MATTSON HILL SP

PFN: LUA2022-0071

COVER SHEET

MATTSON HILL SP
CITY OF LAKE STEVENS, WASHINGTON
PORTION OF SECTION 8, TOWNSHIP 29 NORTH, RANGE 6 EAST, W.M.

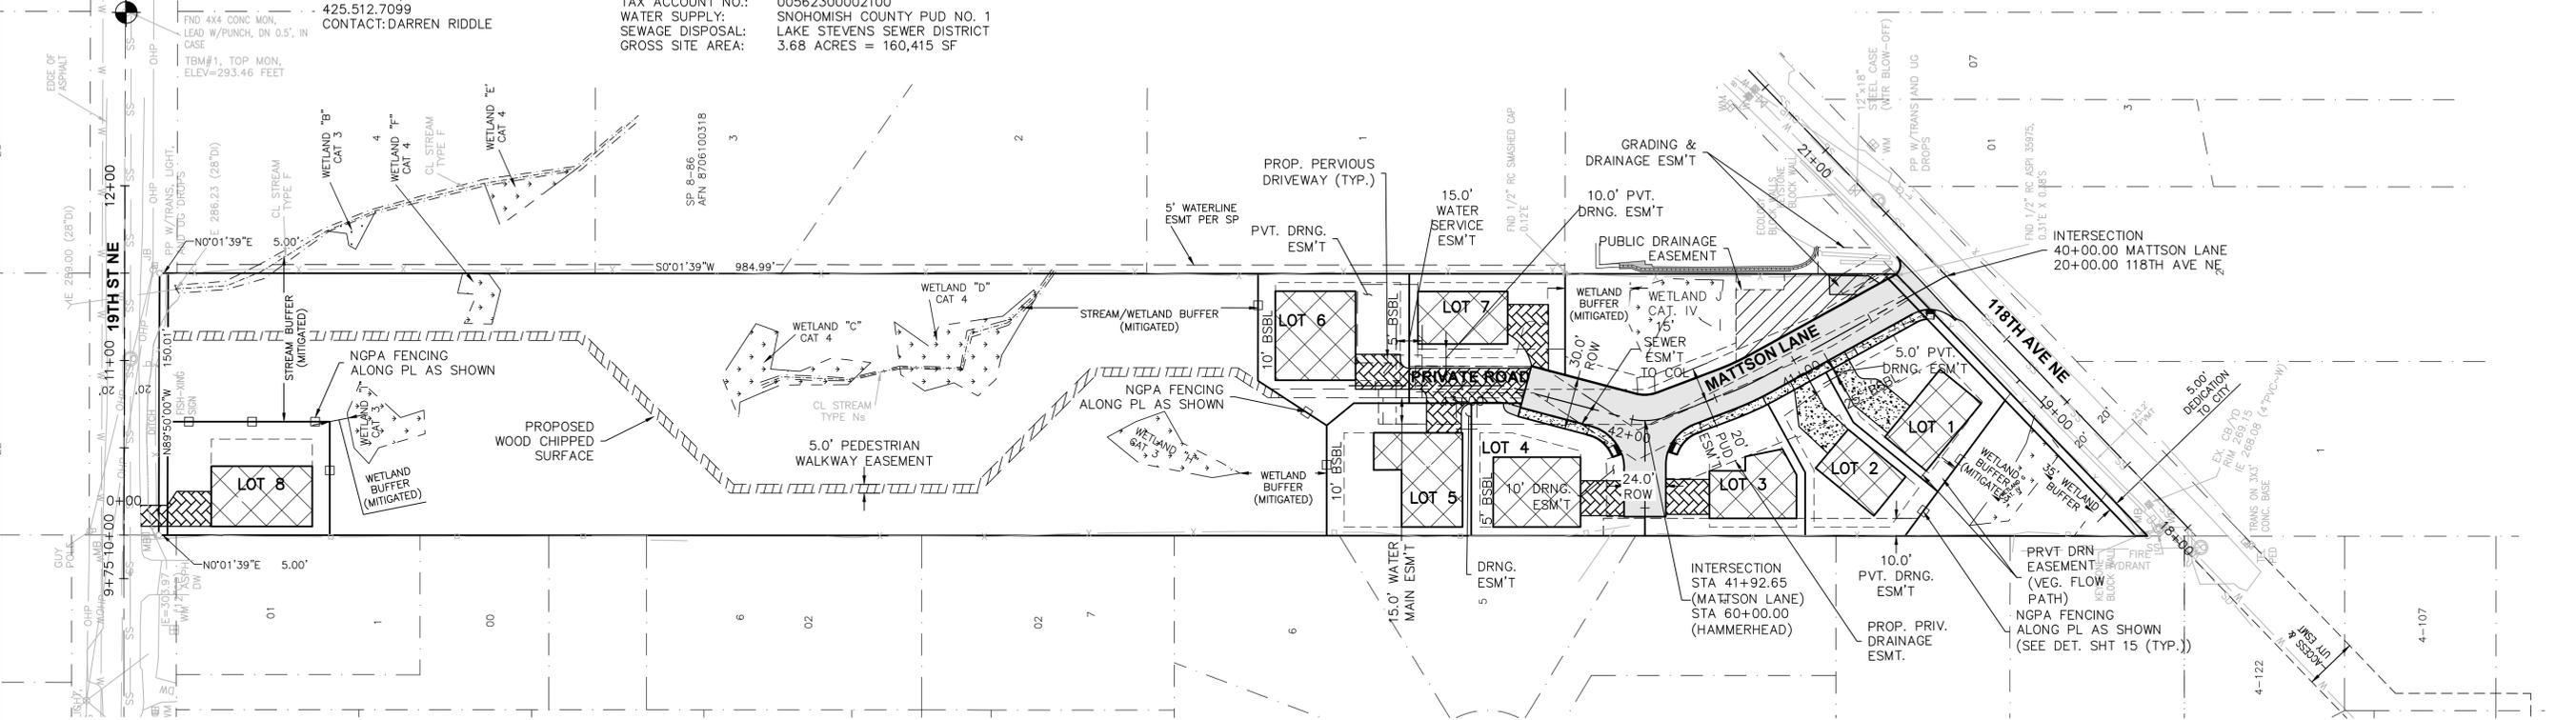
A City of Lake Stevens ROW Permit is required prior to any work within the existing ROW.

Per LSMC 14.60.400 all public streets, sidewalks, and other common areas or facilities in subdivisions shall be sufficiently illuminated to ensure the security of property and the safety of persons using such streets, sidewalks, and other common areas or facilities. An approved illumination plan is required prior to scheduling the pre-construction meeting.

No parking signs may be required along new public streets. Coordinate with the Fire Marshall and PW Inspector for requirements.

**RAMP DETAIL
MATTSON LANE**

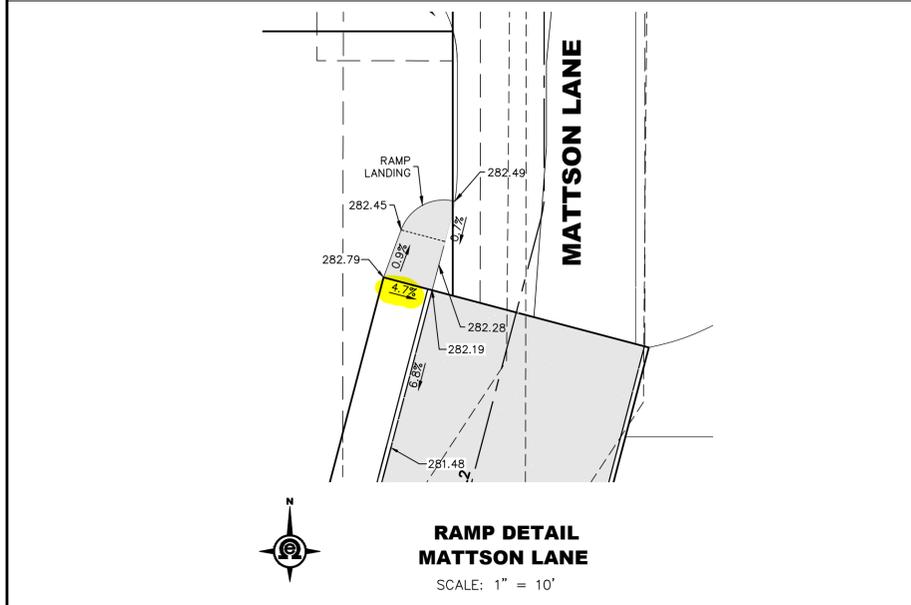
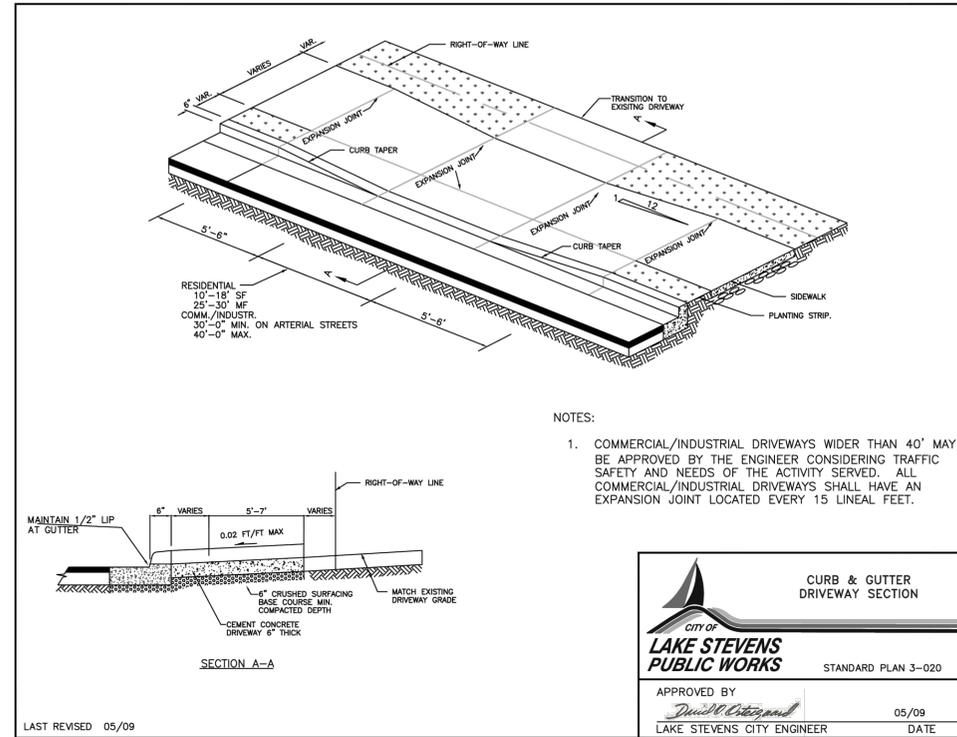
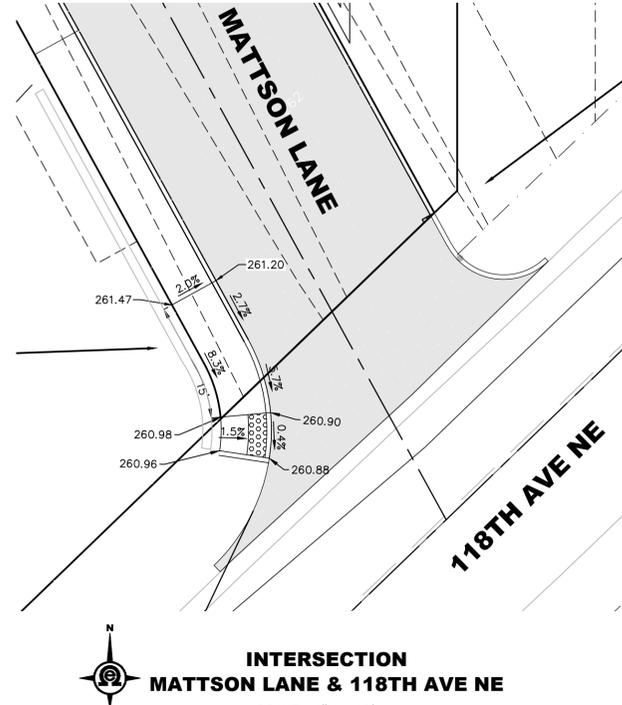
All curb ramps and sidewalks to meet PROWAG and ADA Standards. Refer to WSDOT Standard Plans for guidance. Any elements that do not meet standards must be documented and approved by the City through an MEF prior to construction.
